TRANS/WP.29/2004/20
5 December 2003

PROPOSAL FOR DRAFT SUPPLEMENT 10 TO THE 03 SERIES
OF AMENDMENTS TO REGULATION No. 36

(Large capacity passenger vehicles)

"Figure 6b

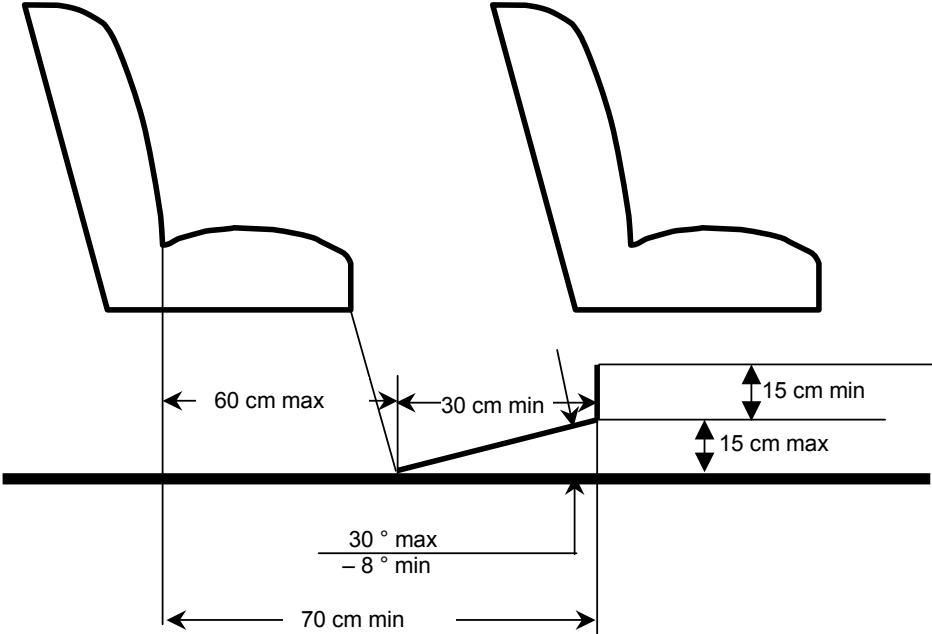
"5.7.8.5.2. For a seat behind a seat and/or a seat facing the gangway, a minimum clear foot space of at least 300 mm depth and a width according to paragraph 5.7.8.1.1., shall be provided as shown in annex 3, figure 6b. The local presence in this space of seat legs and of intrusions as provided by paragraph 5.7.8.6.2.3. shall be permitted provided that adequate space remains for the passengers' feet. This foot space may partly be situated in and/or above the gangway but shall not create any obstruction when measuring the minimum gangway-width in accordance with paragraph 5.7.5."

Insert a new figure 6b, to read:

SPACE FOR SEATED PASSENGERS BEHIND A SEAT AND/ OR A SEAT FACING THE
GANGWAY
(see paragraph 5.7.8.5.2)
